Mr. Kolb  
DG Energy and Transport  
Energy Efficiency  
TREN D 3  
European Commission  
B-1049 Brussels

**EUP lot 1 - Ecodesign requirements for boilers  
Preliminary comments on document 3, 5 & 6 in  
preparation of 16 december 2009**

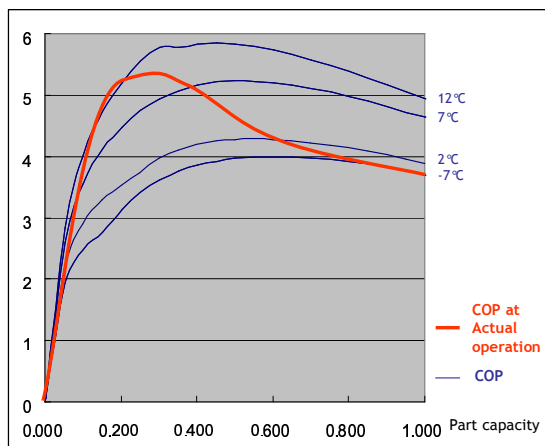
The calculation assumes a certain degree of losses, which are clearly related to the installation and user behaviour. Manufacturers are not able to predict or improve these kind of impacts, and rely for that matter to specific application calculations such as the ones provided for EPBD.

Also these assumptions of losses are not reflecting real life situations. In case of high investment cost products, such as heatpumps, the consumer will in first place reduce the heat demand by improving the insulation, will install double glazing and do all that matters to reduce the energy consumption. At that stage, it is clear that the losses will have been significantly reduced, in contradiction with the present calculation methodology.

It is clear that the impact on least life cycle cost has not been evaluated throughout the study of lot 1, as such, we feel that system losses should not be included in present calculations.

As a conclusion, we feel that these losses, should be excluded from the calculation to ensure a heat generator approach.

The attached proposal for revision of document 5 & 6 provides a proposal how this calculation should be adapted to serve this comment.

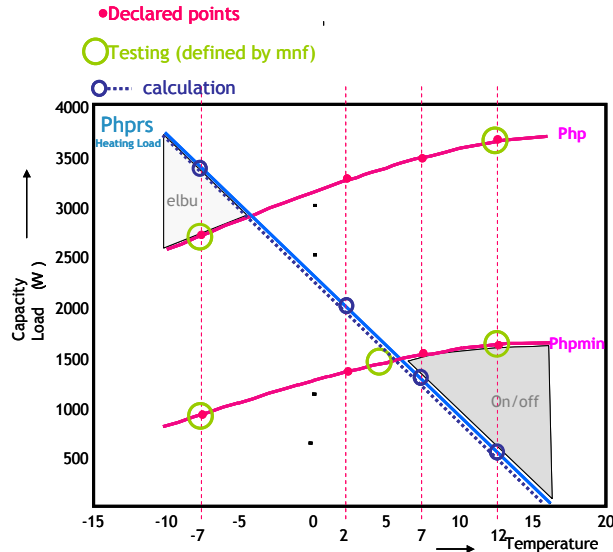
1. In cold climates, current calculation requires much higher system temperatures than average climate. The system temperatures will not change that much since buildings in colder climates are better insulated than buildings in average climates reducing the heat demand, as such systemtemperatures at extreme conditions will not increase. Consequently the systemtemperature at extreme condition for cold climates will be the same as the extreme condition for average climate. This needs further correction.
2. In current calculation tool, systemtesttemperatures (Tsystst) for floorheating are the same as for radiator heating. Correction is to be made as follows:

Floorheating systemtemperatures should not exceed 35°C. For floor heating the temperatures are limited as the floor temperature should not be higher than 29°C.

Tsystst5	34,5
Tsystst4	32
Tsystst3	27,5
Tsystst2	26
Tsystst1	24,5

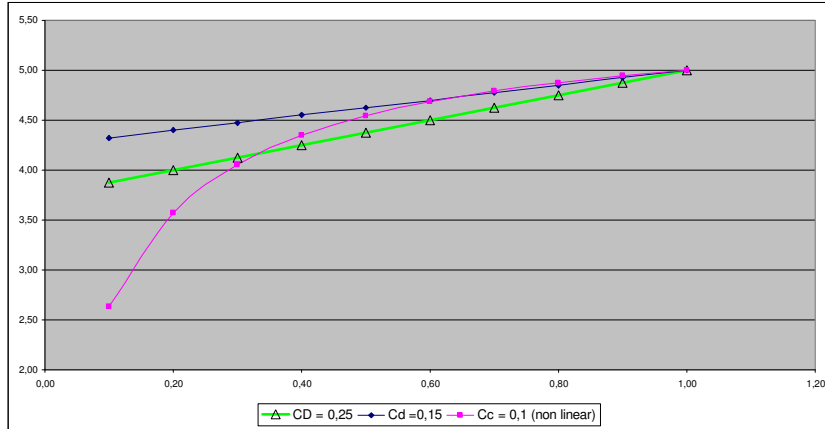
The default Cd factor of 0,25 is only valid for air to air products and should be reduced for air to water systems. This is based on the simple fact that for air to water products, the pressure equalisation is negligible due to the small water heat exchangers. When the compressor stops, the refrigerant will migrate from high temperature (condensor) to low temperature (evaporator). This also causes a large heat transfer in the system.

In case of air to air, with big heat exchangers, much more refrigerant must be compressed when the unit starts again. In case of air to water, less energy has to be used, due to smaller size of heat exchanger.

In addition to that effect, due to the higher temperature of the water in the condensor, the unit will require less power to heat up the refrigerant mass and heat exchanger of the unit.

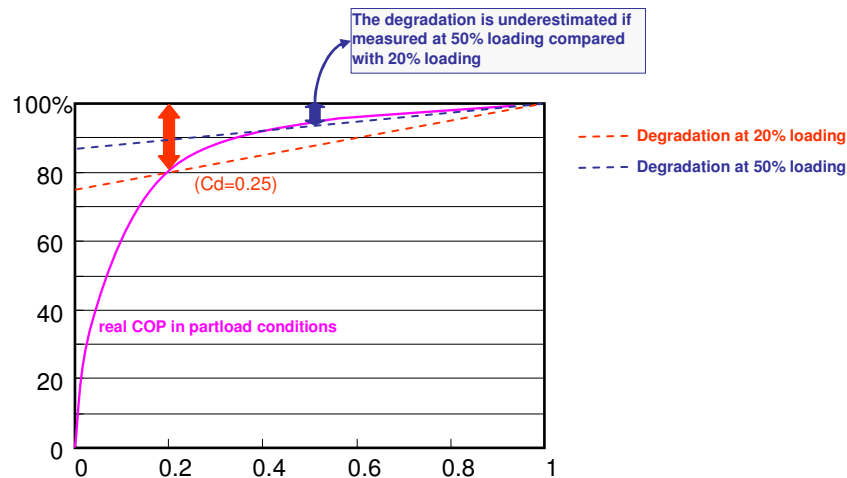
As such, a Cd factor of 0,25 is not taking into account the particularities of air to water systems and should be reduced. However, since the linear formula is proposed to be used, we can not find a good value for the moment. In prEN 14825, a non linear approach has been taken and as

prEN 14825 is proposing default value for the Cd factor of 0,25, but this is presumed based on testing 6'on and 24'off (20% on)

such we can for the moment not make a good correlation. Tentatively we propose to use 0,15 instead of 0,25.

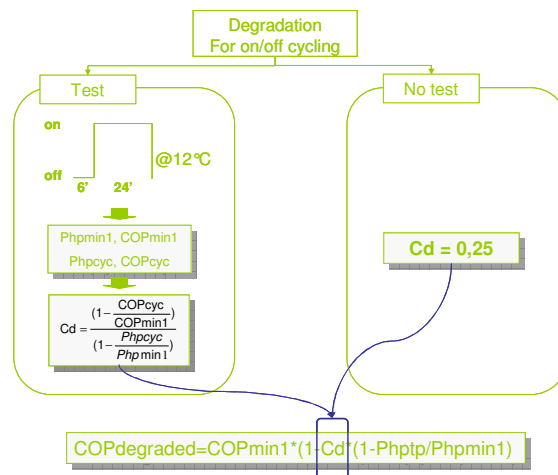
The perception of using the default value is incorrect. If a manufacturer opts to apply the default value, and does not want to perform test for technical reasons (because the capacity is too low, and uncertainties of measurement would be too high), then this default Cd factor needs to be used for the degradation. In the proposal there are formulas included (line 86a) that are indicating how to define COP<sub>cyt</sub> for the default value, but this is redundant. In the excel the approach is somewhat confusing so we want to have the method clear and transparent.

If the manufacturer however chooses to perform tests for determining the Cd factor, then in this case, it should be possible to include that Cd factor. The calculation method has to be corrected in that sence. Necessary changes have been done in the revised document.

The test method should be in line with what prEN 14825 prescribes, but if there is opted to use another method, this should also be possible. As such, any formula used should allow for different loading.

EPEE proposes to use:  $Cd = (1 - (COP_{cyc} / COP_{min1})) / ((1 - (Ph_{cyc} / Ph_{min1}))$

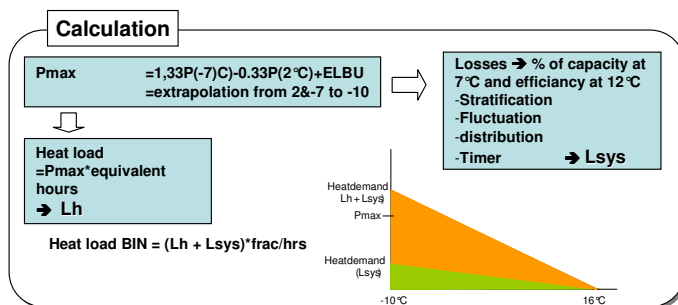
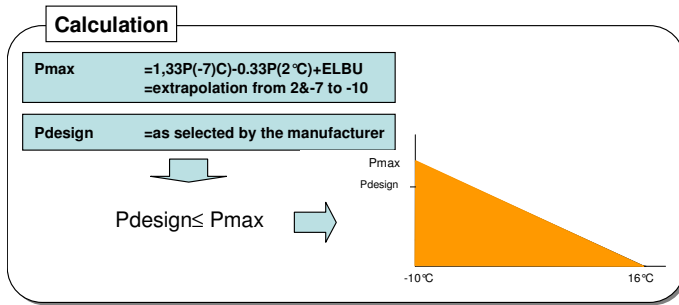
In former meetings there has been agreed that the manufacturer may declare different heat demands where he sees fit, as long as this heat demand does not exceed the capacity of the heat generator.

This approach is now not clearly reflected in the calculation.

EPEE proposes that the manufacturer needs to be able to declare a “Pdesign” which would be the factor deciding the heatdemand. It seems natural for heatpump manufacturers to define the heatload and then declare the COP at conditions matching as close as possible the heatdemand.

The way heat demand is defined for now is not transparent for the user of the calculation method.

While we feel it can be simplified much more as follows:

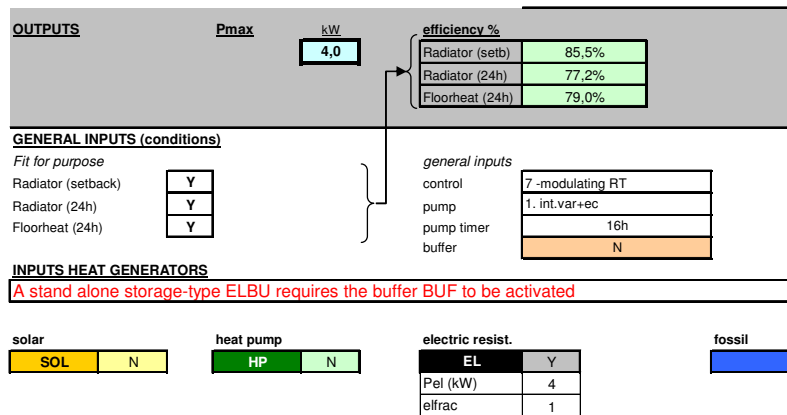
The efficiency drop of inclusion of different types of pumps is unclear, and why it is 5% for floorheating in comparison to radiatorheating is unclear.

Due to set back, 1,5 times more pumppower is required, however we fail to understand why.
